ATTACHMENTS TO MINUTES ORDINARY COUNCIL MEETING

19 APRIL 2024

Attachment 2 – Updated Council Report

Material Change of Use – Holly & Guy Collier C/- Adapt Development Management Pty Ltd: 49 Connor Street, Stanthorpe

Figure 3: Proposed floor plan

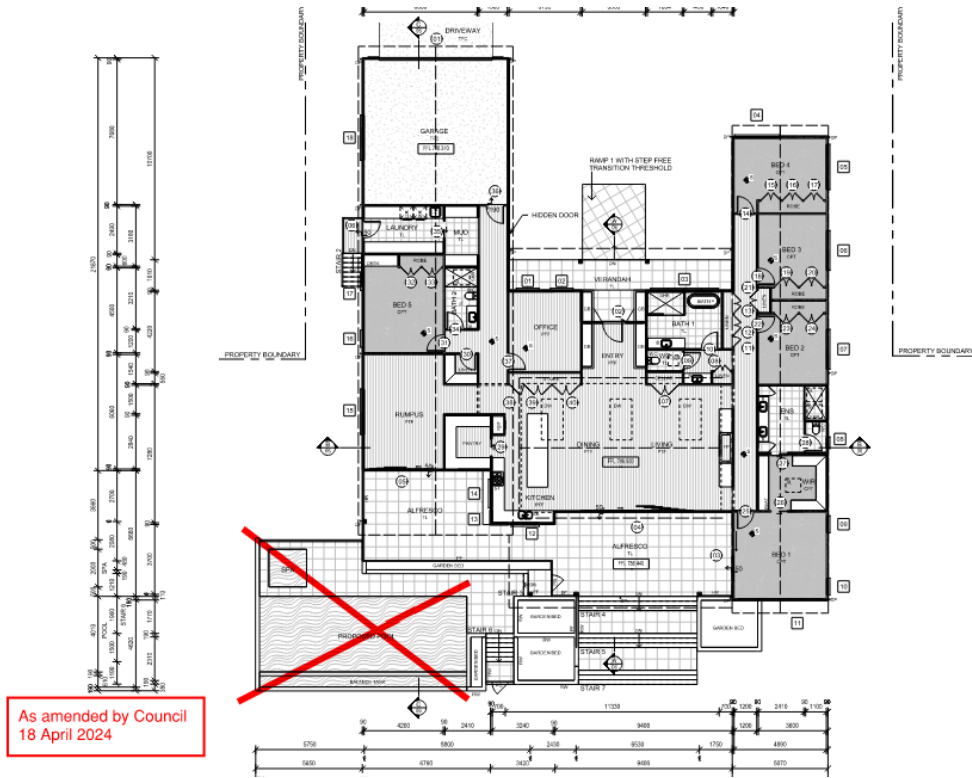
The floor plan is illustrated in Figure 3. An amended floor plan may be required to meet the conditions applied to any approval. The applicant has confirmed the intent is to retain the existing Dwelling house on the site whilst the new dwelling is being constructed. Once the new dwelling is completed, the existing Dwelling house on the lot will be demolished, prior to the final building certificate being issued for the proposed Dwelling house. The existing crossover to Connor Street will not change. The floor plan shows a large alfresco area and swimming pool at the rear. It is important to note that the proposed pool area does not form part of this application, as illustrated below.

| Plan Name | Drawing No. | Date |
|---|--------------------|--|
| Proposed floor plan – Revision A, as amended by Council | BA- 04 | 1 June 2023, amended by Council on 17 April 2024 |

Figure 4: Site plan with proposed location of Dwelling house and Flood hazard overlay

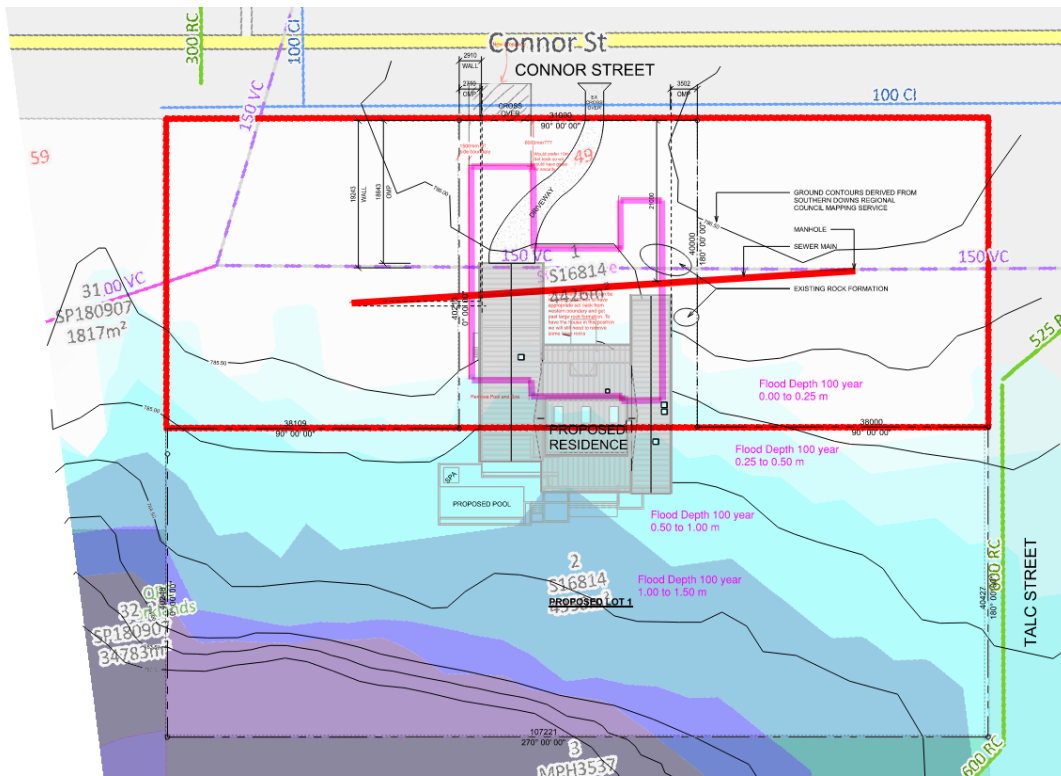
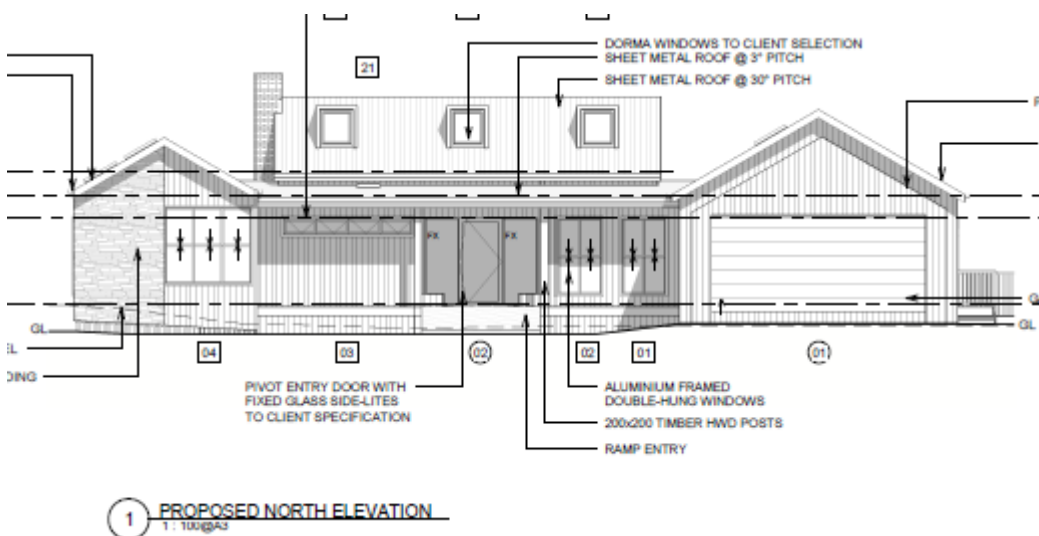
The new proposed site plan is illustrated in Figure 4 and the on-site changes from the previous versions are summarised below:

- Removal of the proposed pool and spa area and the associated solid block work to support these elements.
- The Dwelling house is moved closer to the Connor Street frontage.
- The general layout remains the same, however, due to site constraints (granite boulders), a reduction in the width of the Dwelling house may be required.
- The Dwelling house is now wholly located over the Council’s reticulated sewer main.

The proposed new location of the Dwelling house in relation to the potential flood depths is illustrated in Figure 4, in pink.

Figure 4 was submitted to Council on 17 April 2024 and locates the garage 6.0 metres from the Connor Street frontage. Subsequent conversations with the applicant has confirmed that the preferred location will result in the garage being setback 10 metres from the front boundary.

| Plan Name | Drawing No. | Date |
|---|--------------------|--|
| Proposed site plan – Revision B | BA-03 | 16 August 2023, received by Council on 17 April 2024 |

14. The building setback from the Connor Street frontage may be in line with the existing shed structure immediately to the west of the proposed site.
15. A copy of the Certificate of Compliance for Plumbing and Drainage Works is to be provided to Council. (See advisory note below.)

Figure 5: Elevations

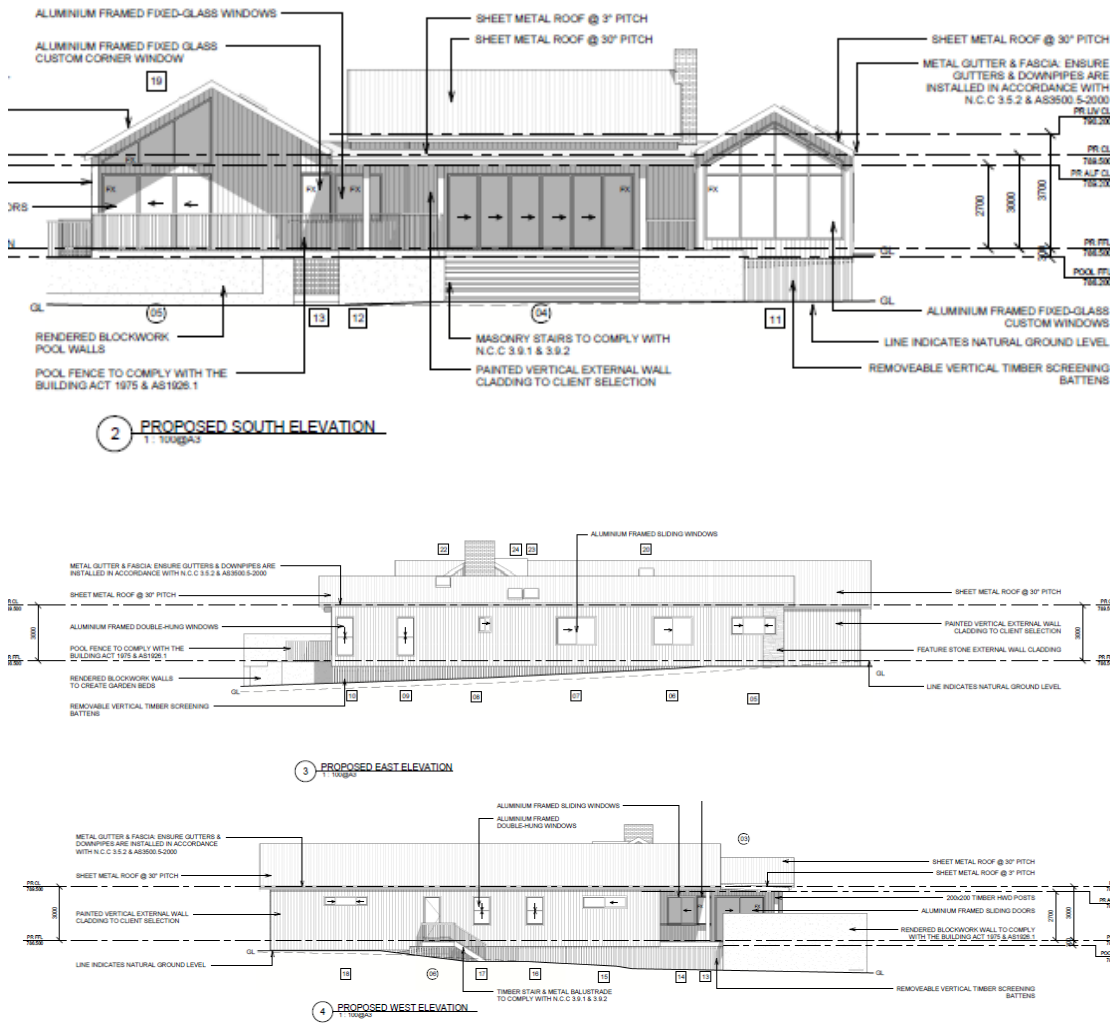
Elevations and perspectives are shown in Figures 5 and 6. The elevations confirm the use of timber vertical battens to screen the area below the floor level of the Dwelling house. As noted earlier, if the application is approved, amended plans will need to be provided and approved. This can be achieved by delegated authority if they comply with the approved conditions.

It is relevant to note that the amended design is likely to require a larger area of slab on ground due to the new location of the Dwelling house. The elevations, as shown in Figures 5 and 6, have been retained in the report, to provide indicative views from the street and assist in understanding how different design elements will be incorporated to mitigate against the impact of flood water.

2. Where there is any conflict between the conditions of this approval and the details shown on the approved plans and documents, the conditions of approval prevail.
3. An amended site plan, floor plan and building elevations **are to be submitted to and approved by Council's Planning Services team prior to the issue of a Development Permit for Building Work.** Construction of the Dwelling house is to be provided and maintained in accordance with the approved details.
